**Amendment to the Certificate of Environmental
Compatibility and Public Need
for the**

**WEST MILTON-ELDEAN 138 kV
TRANSMISSION LINE PROJECT**

OPSB CASE NO. 21-0897-EL-BTA

AES Ohio

Exhibit 3. Preferred Route – Quarry Reroute

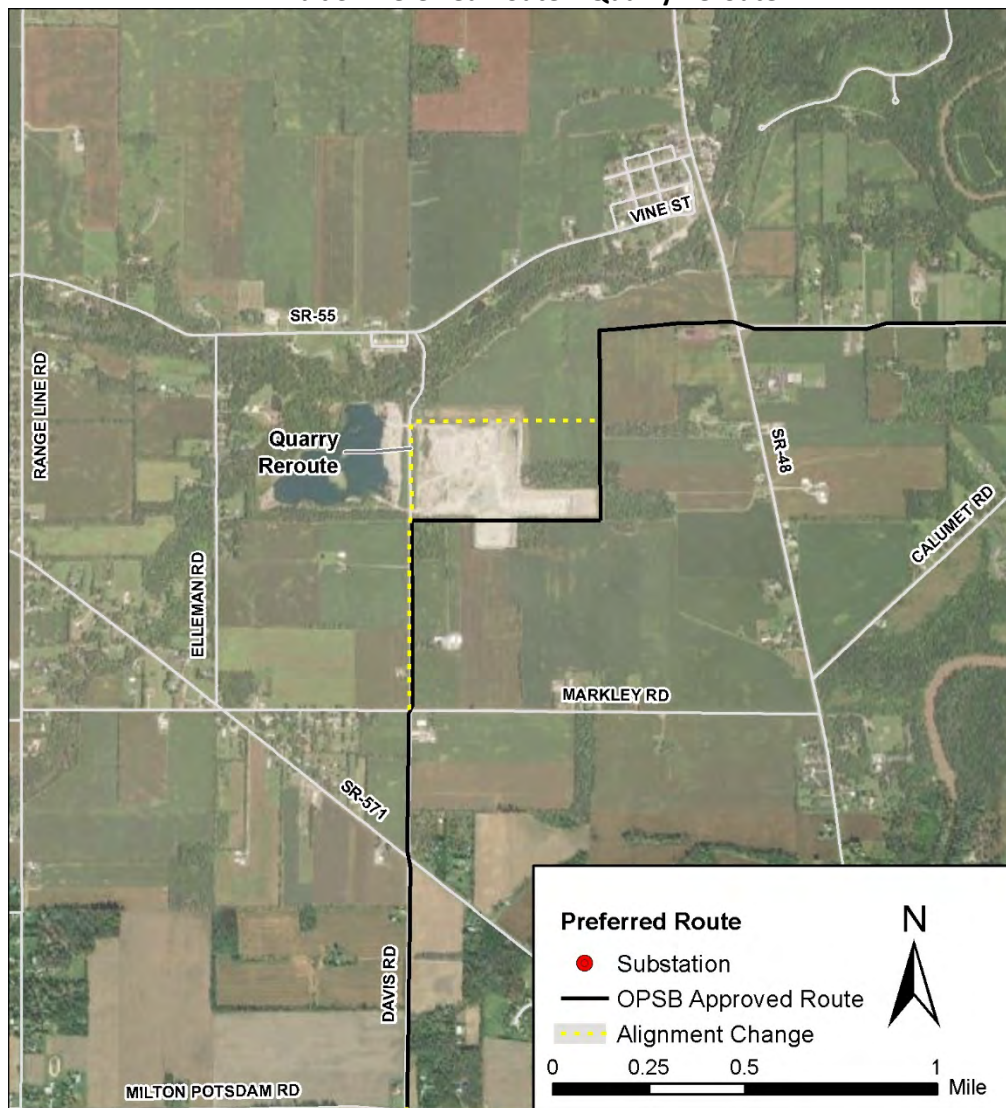
This reroute would move the Preferred Route from the south and east sides of the quarry to the west and north sides. This reroute would also include moving the line from the east to the west side of Davis Road between the intersection of Markley Road and the southeast corner of quarry. This reroute is shown below in Exhibit 3. This change was necessitated by the landowner's development plan for the property and finding a mutually agreeable option with AES Ohio. AES Ohio has obtained an easement from the landowner for this reroute. No new property owners would be affected by this reroute. Impacts to natural and cultural resources are not anticipated from the reroute based on environmental and cultural field review, desktop assessment, and agency correspondence

Exhibit 4. Preferred Route – Forest Hill Road Reroute

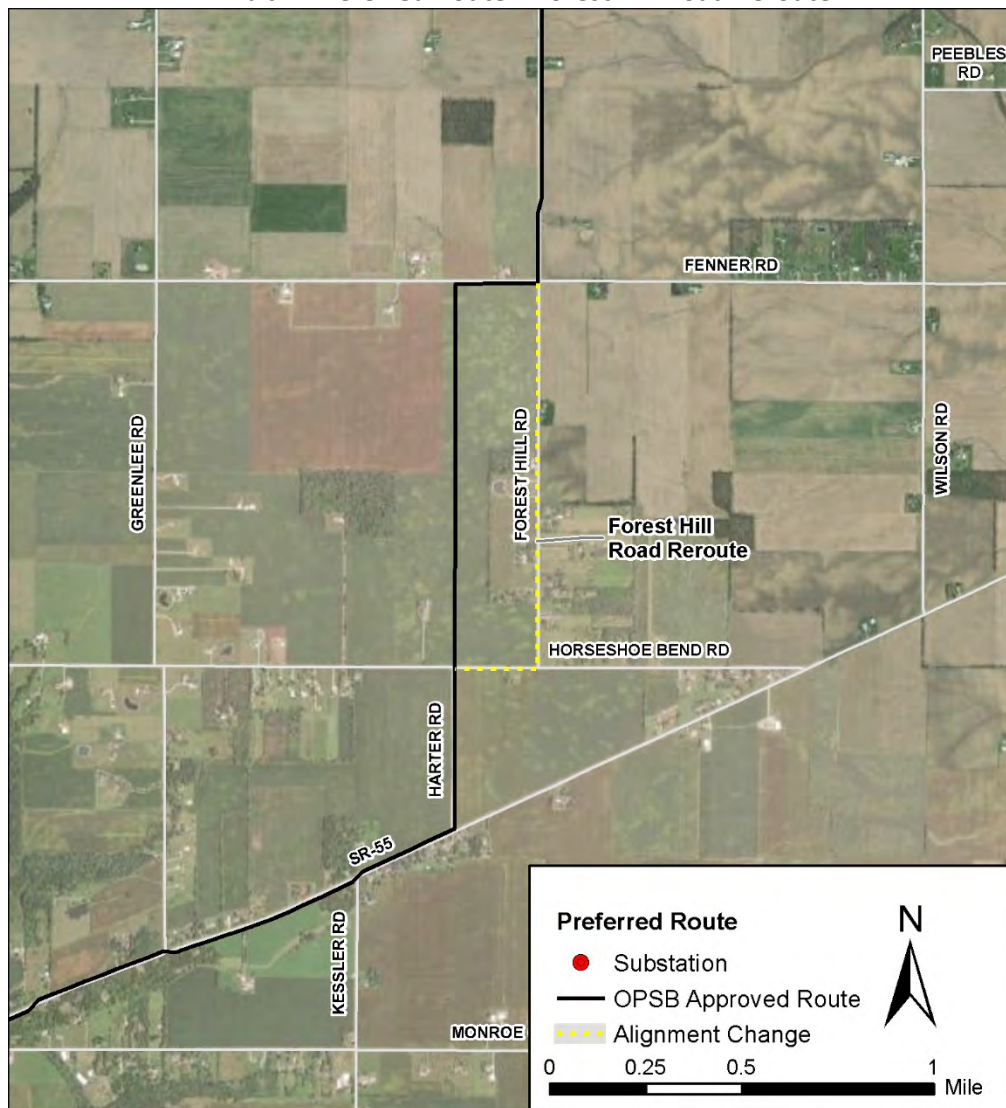
This reroute would move the Preferred Route about 1,150 feet east and from agricultural fields to paralleling the west side of Forest Hill Road. This reroute would also include about 1,150 feet of line paralleling the south side of Horseshoe Bend Road. This reroute is shown below in Exhibit 4. This change was necessitated by AES Ohio and the landowner unable to reach an easement agreement. This reroute will affect five new landowners. AES Ohio has obtained an easement from all five landowners for this reroute. Impacts to natural and cultural resources are not anticipated from the reroute based on environmental and cultural field review, desktop assessment, and agency correspondence.
